Ref: R.18-10-007

RE: MUSSEY GRADE ROAD ALLIANCE COMMENTS ON 2020 WILDFIRE MITIGATION PLANS OF SDG&E, PG&E, SCE

WILDFIRE MITIGATION PLAN COMMENTS ON BEHALF OF THE MUSSEY GRADE ROAD ALLIANCE

Figure 1 - Outage rate as a function of wind speed¹⁸

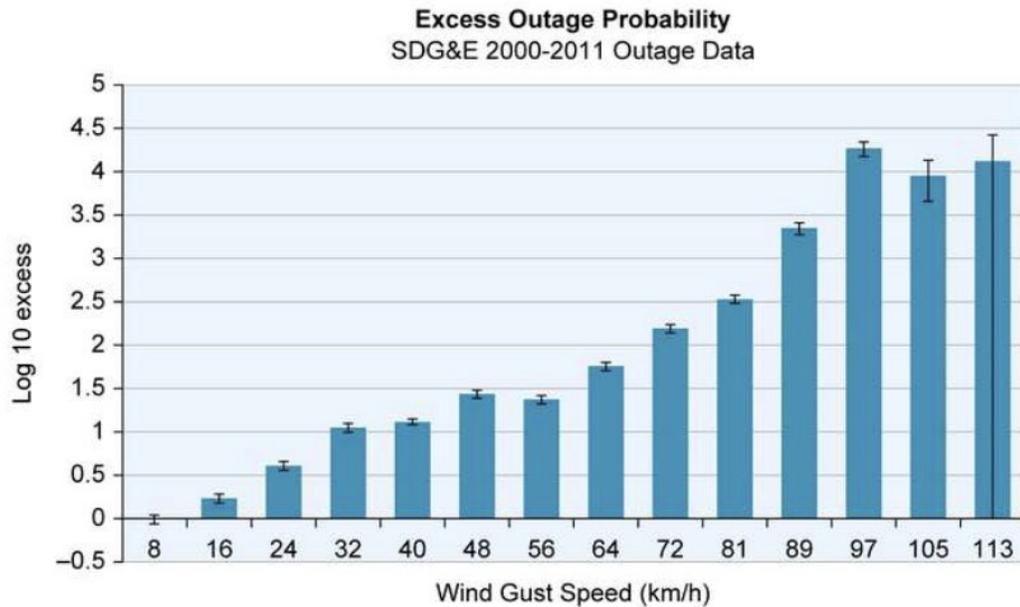
The importance of the relationship between wind speed and outages is seen in Figure 1, which shows a ten-fold increase in outage rate for every 15-20 mph increase in wind speed. As MGRA has described in a number of its previous filings,¹⁷ the utility-specific fire index does not allow a similar resilience metric to be established. Also

Remove Red Flag Warning – day – miles as a tracking metric, or supplement it with a wind speed metric.

Figure 2 - PG&E Fire Potential Index dependency on wind speed for RH 20%, T 80F, Forest, DFM10 hr 6%.

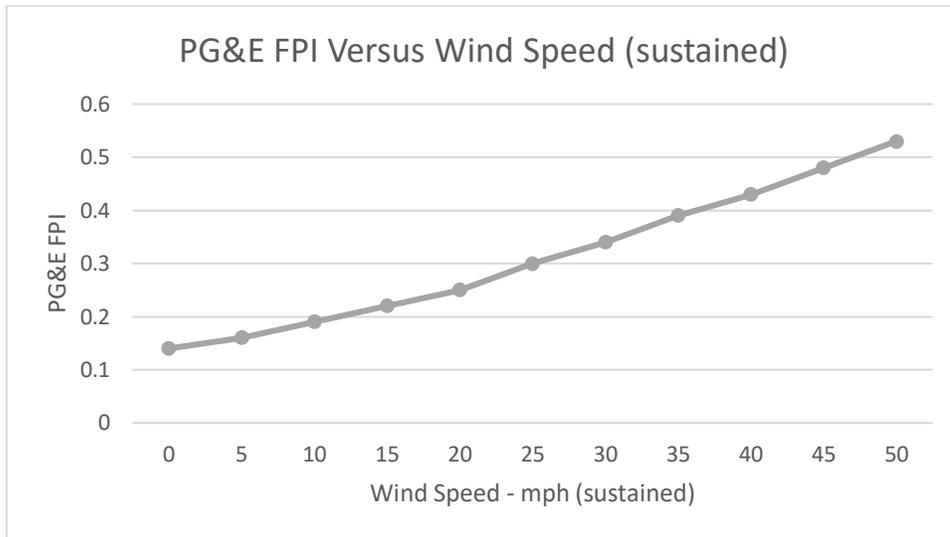
As can be seen, this is a quasi-linear relationship, which might be expected on theoretical grounds since traditional fire modelling predicts a linear relationship between wind speed and fire area spread rate.⁴⁴ SDG&E's model, in contrast, is more coarse grained, having only 2-3 tiers for wind speed at any given temperature.⁴⁵ Based on the presentations in the 2020 WMPs, it is tempting to say that PG&E has the most sophisticated approach to calculating FPI, however without delving into the details, which WSD has the opportunity to do, it would not be good to reach firm conclusions. SCE is the laggard and should improve its discussion of its FPI calculation in its WMP.

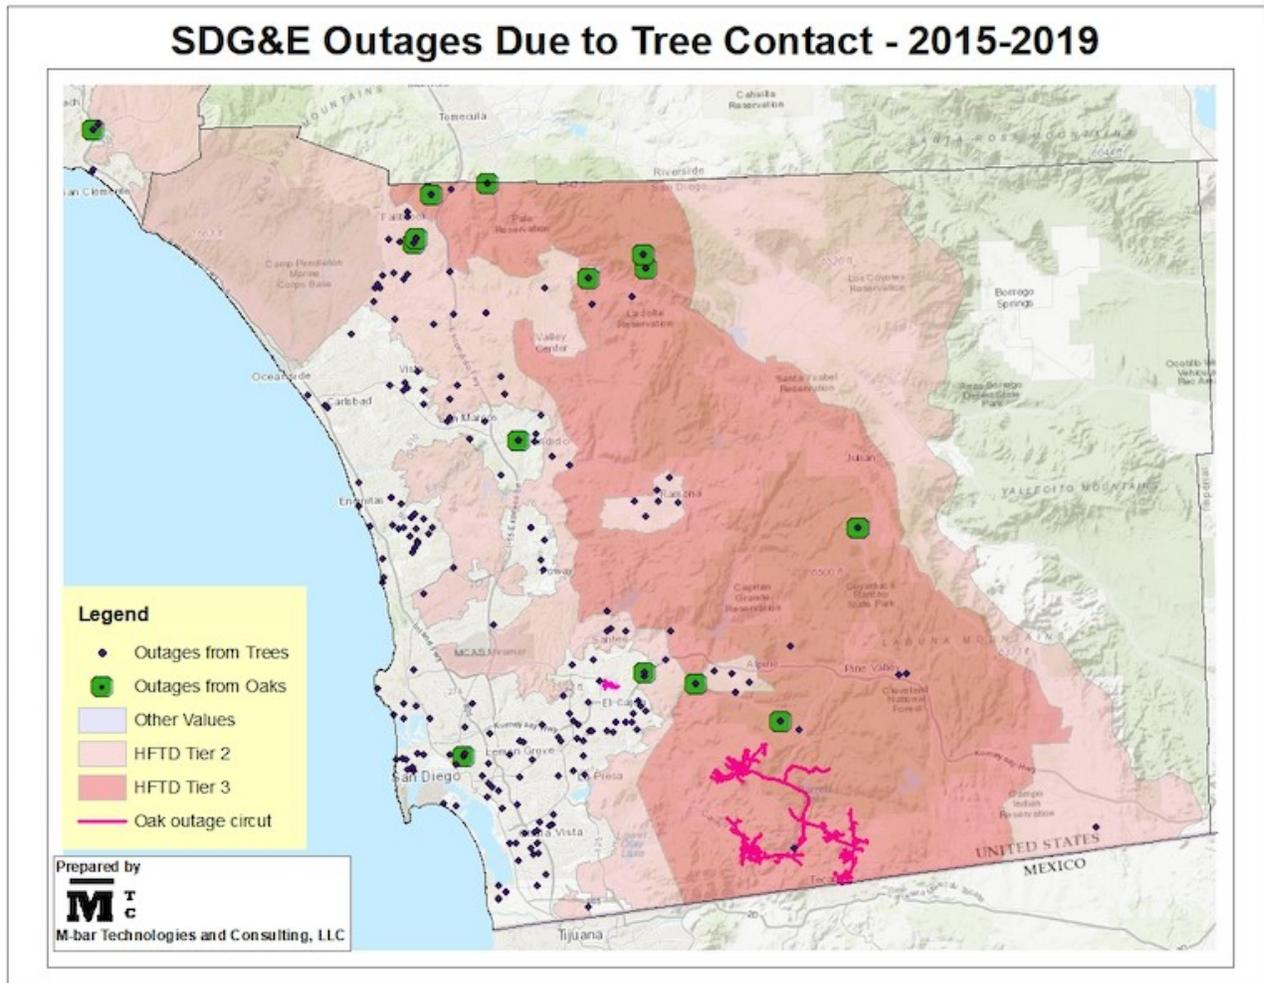
The map shows the High Fire Threat District Tier 2 and Tier 3 areas in the SDG&E service area. All tree-related outages are indicated by small dots. Additionally, specific outages caused by oak trees are indicated by larger green circles. Oaks are specifically called out because they are the only significant native tree in the SDG&E service area aside from sycamores. Sycamores are not given special consideration, however, due to their greater relative likelihood of causing ignition.

Using the SDG&E data, it is possible to analyze the merit of the 25 foot SDG&E trim distance. Looking at the data in more detail, two of the oak incidents shown in the figure were due to non-SDG&E trimming crews, and one was a de-energization for trim. If we exclude these from the sample, there are 10 total oak-related outages in the HFTD Tier 2 and Tier 3 areas in SDG&E's 5 year outage history. For each of these, given the trim distance, tree height, and tree distance from

SDG&E should concentrate its 25 foot radius EVM trim and removal program on trees that are particularly fast-growing, particularly prone to ignition-causing failure (such as eucalyptus and sycamore), and those that show signs of disease or structural defects.

Figure 4 - SDG&E MAVF Expected Value versus 99th percentile safety indices. The point for wildfire risks is an outlier in the top right corner.

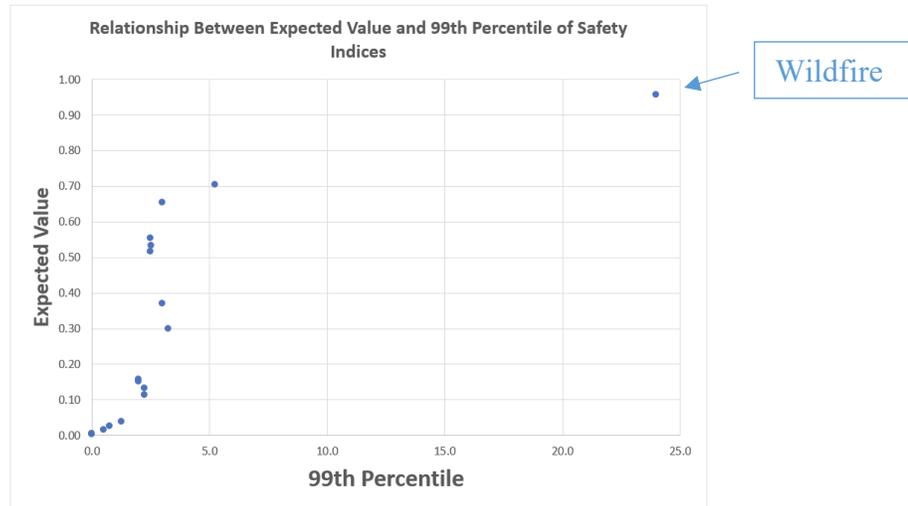
The data point for wildfire risk is denoted with an annotation. As can be seen, wildfire presents an extreme outlier when 99th percentile values are compared to expected values for safety indices. This means that the contribution of extreme events to the risk estimate is much higher than for other risk sources. This outsized contribution of extreme events to risk considerations is exactly what MGRA raised as an issue during the S-MAP proceeding,^{95, 96} and SDG&E’s 2019 RAMP analysis validates our concern. It is precisely the 99th percentile that we need to worry about. The Witch fires, the Camp fires, the Woolsey fires, these are all 99th percentile events and they are the reason for most of the death and damage caused by power line fires, the reason that California’s power line fire problem is now known internationally, the reason for intense state government scrutiny of this issue.

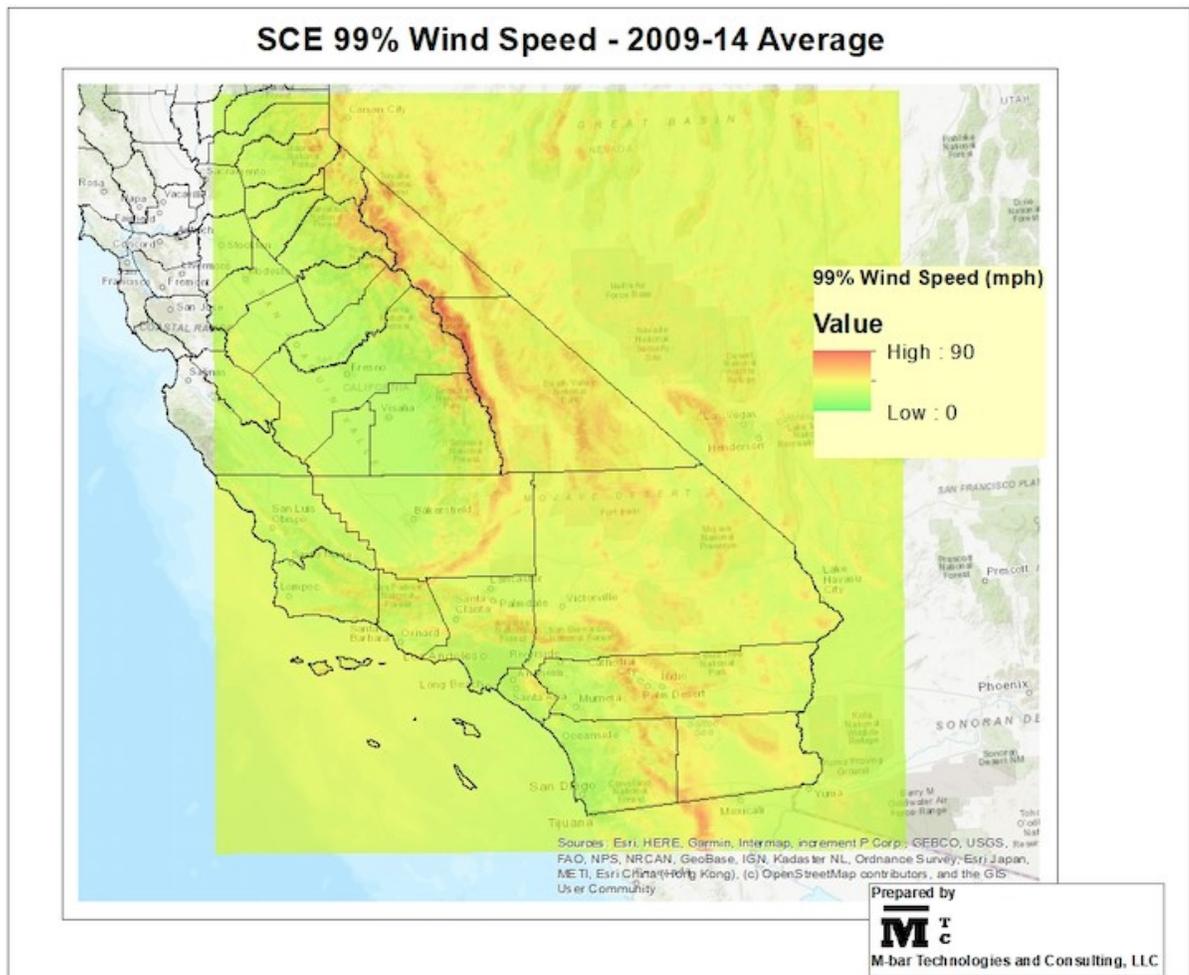
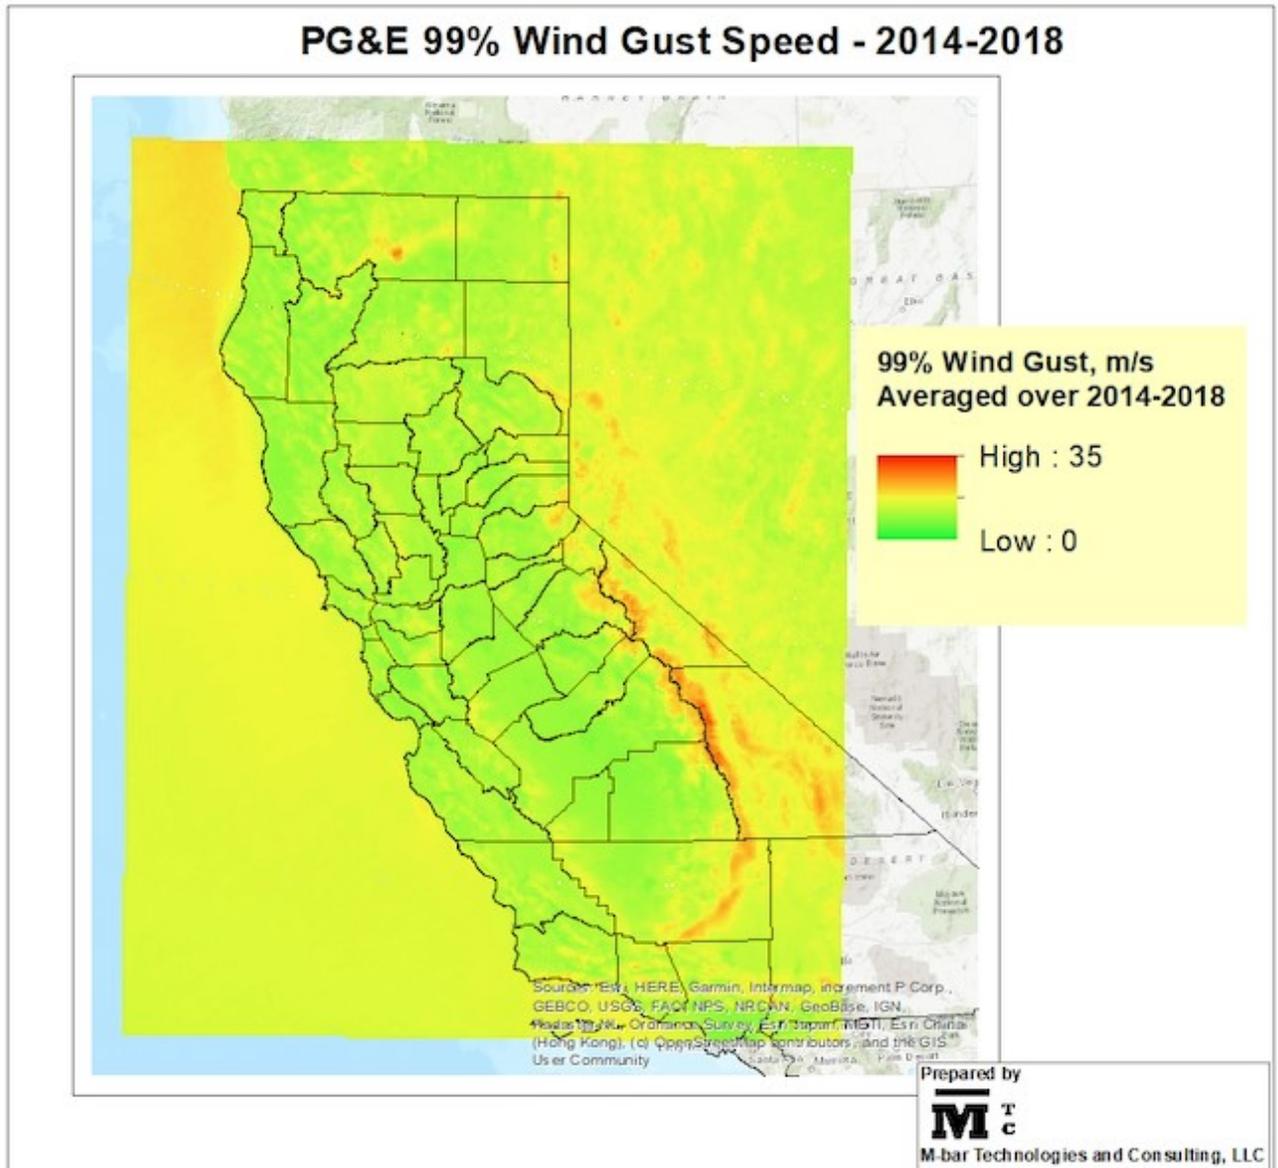
While Figure 5 and Figure 6 show a qualitative similarity between the SCE and PG&E wind modelling, taking the ratio reveals distinct differences. Most notably PG&E’s model predicts stronger winds on the western slopes of the Sierra Nevada and the eastern slopes of the coastal ranges. It is unlikely that this is an artifact due to geographic coordinate offset, since that would tend to create a pattern that was uni-directional. The fact that PG&E’s model predicts higher wind on all sides of the Central Valley is striking. SCE’s model predicts higher winds than PG&E’s in the mountains of Santa Barbara and Ventura counties, as well as San Benito County. These represent significant differences between the two models, with 33% of the data having values that differ more than 12% from the value expected if the models were identical.

WSD should request additional information from the three major IOUs to help clarify whether there are significant differences between the weather models used and if so what their origin and implications are. If there are significant differences between models, WSD should host weather model workshops where meteorologists from the different utilities, WSD, and external experts can discuss improving the approach to utility weather modeling.

Figure 9 - Comparison 99% wind speed for SCE model (color scale) and SDG&E weather station data (proportional circles). SDG&E “known local wind” conditions for a 50 year recurrence interval are shown by the contours.

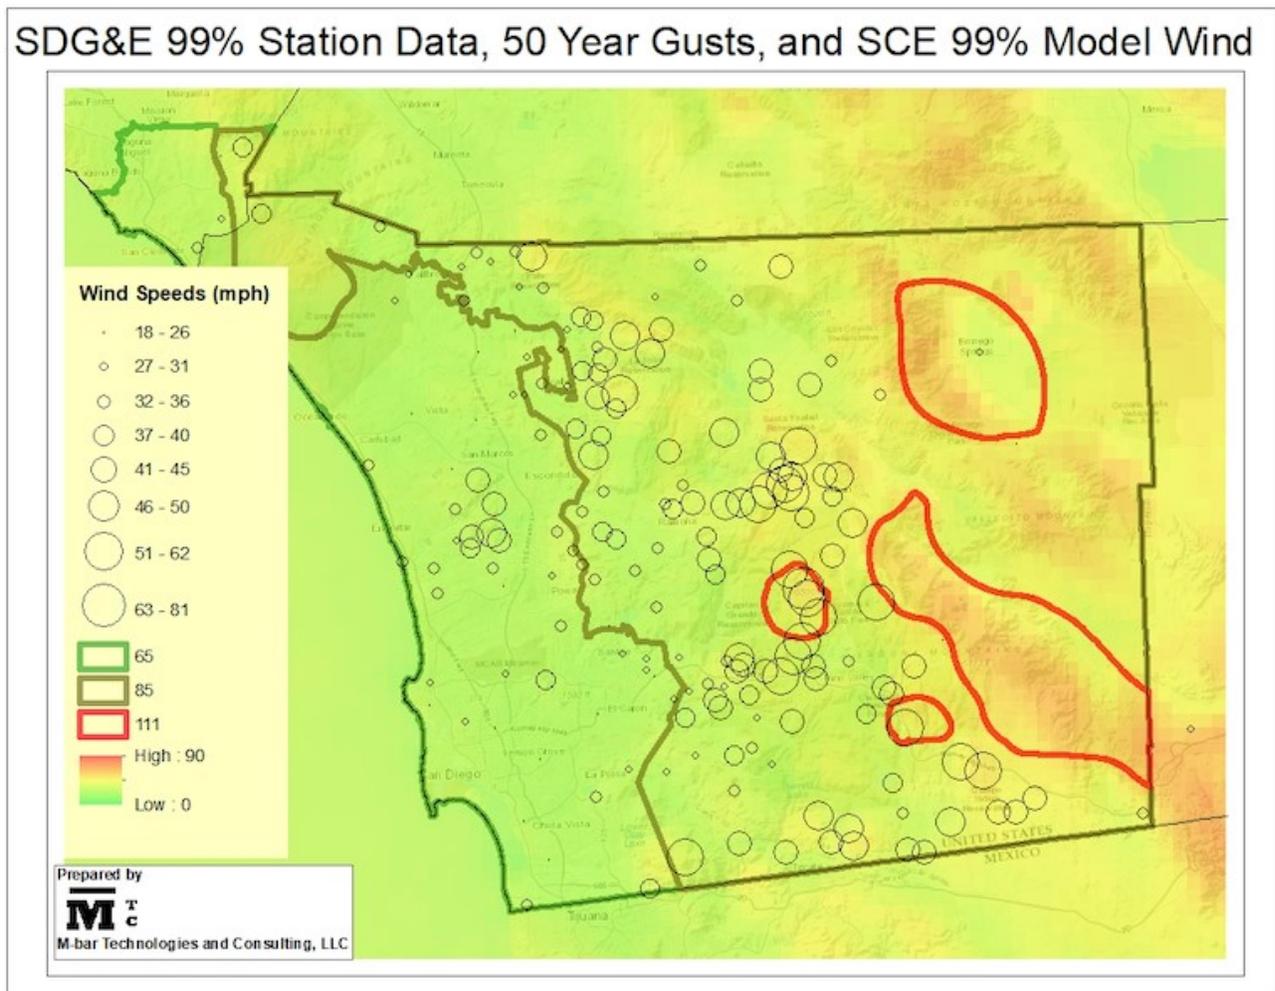
Comparing SDG&E’s “known local wind” conditions for a 50 year recurrence interval with SCE’s model shows some noticeable differences. There is less of a mismatch between weather station data in the desert regions, but more importantly the SCE model shows an additional “warm spot” that is supported by SDG&E weather data in central San Diego County, in the vicinity of Santa Ysabel – the origin point of the 2007 Witch Fire. An area of equivalent wind intensity to the south of that area was assigned a 111 mph wind loading by SDG&E.

WSD should request additional information from the three major IOUs to help clarify whether there are significant differences between the weather models used and if so what their origin and implications are. If there are significant differences between models, WSD should host weather model workshops where meteorologists from the different utilities, WSD, and external experts can discuss improving the approach to utility weather modeling.

Figure 10 - Ratio of SDG&E 99% wind gust station data to SCE's 99% wind model

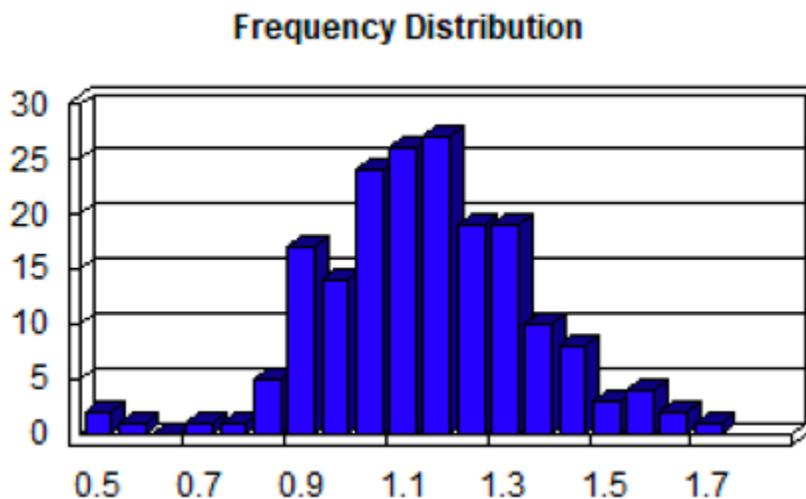
The ratio has a mean of 1.16 and standard deviation of 0.21, not dissimilar from the width of the SCE/PG&E comparison. As with the PG&E / SCE comparison, these data show a marked geographical distribution:

Figure 11 - Ratio of SDG&E 99% wind gust station data to SCE 99% wind model.

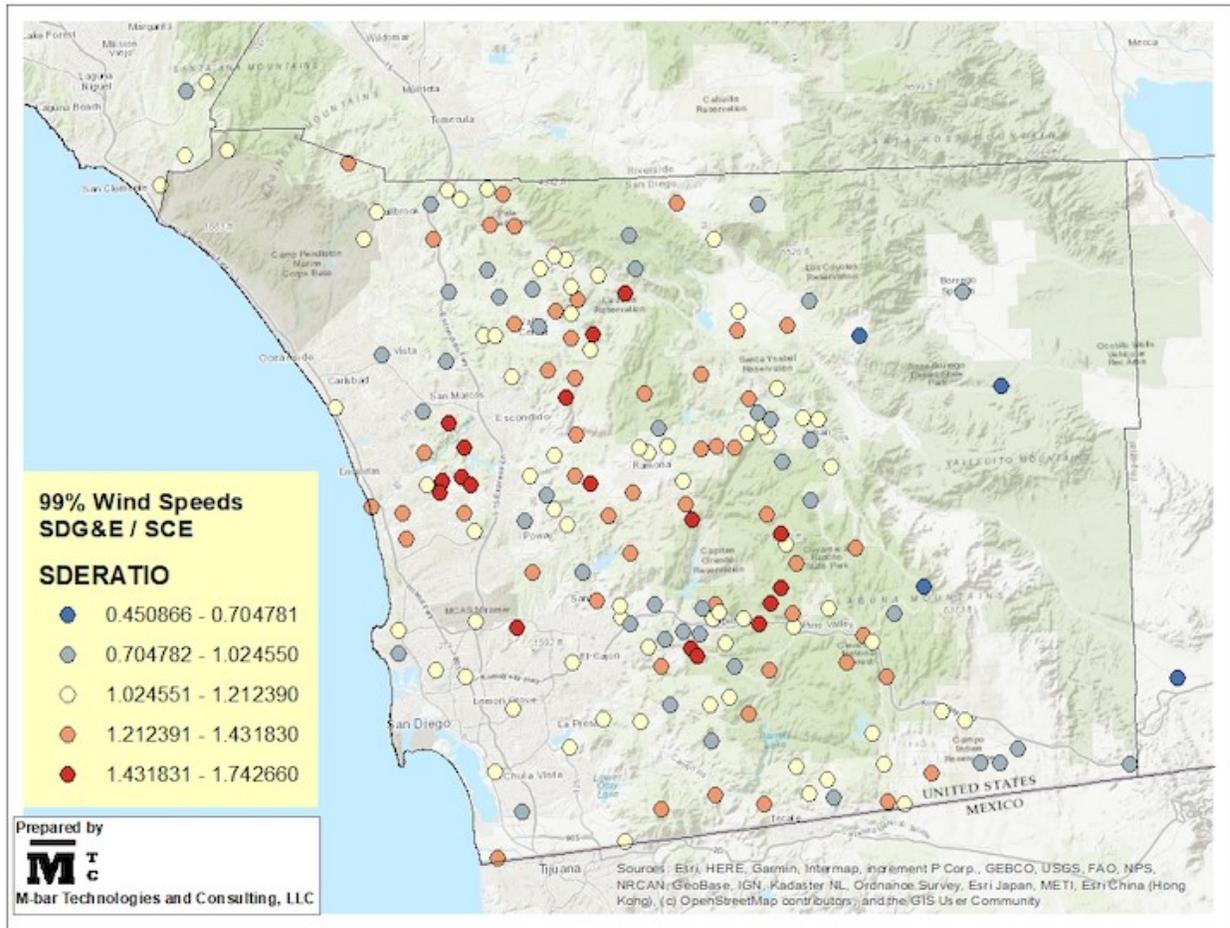
Red points have significantly higher SDG&E 99% wind gust measured values than SCE model predictions, while blue points have significantly lower measured wind speeds than the SCE model. All weather stations east of the mountains have significantly lower SDG&E measured values than SCE's model predicts, while all stations having significantly higher measured values are either on the western slopes of the mountains or in the central coastal cluster mentioned earlier. This is significant because the western slopes of San Diego's mountains are typically where catastrophic wildfires ignite, including the 2003 Cedar fire and the 2007 Witch fire.

Figure 12 - PG&E top ranked risk circuits¹¹⁴ overlaid on its 99% wind speed map. The town of Paradise is indicated on the map.

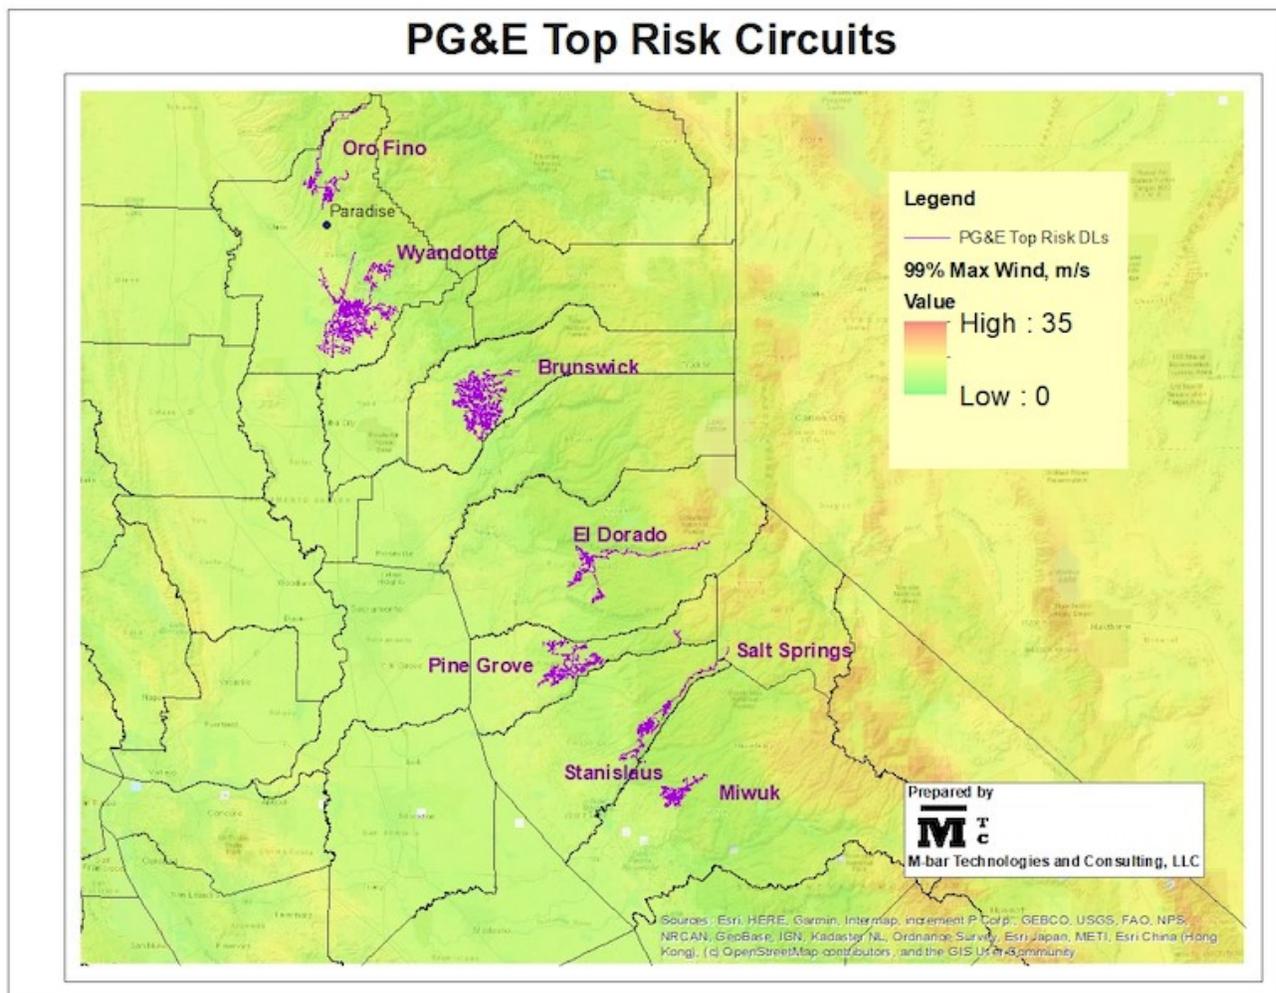
PG&E's top ranked risk circuits, while not necessarily in the highest wind districts, are on the western slopes and foothills of the Sierra Nevada. These circuits overlay areas similar in character to the area of Paradise, scene of the Camp fire. While this prioritization is understandable, it's notable that areas affected in the 2017 fires have lower risk rankings.
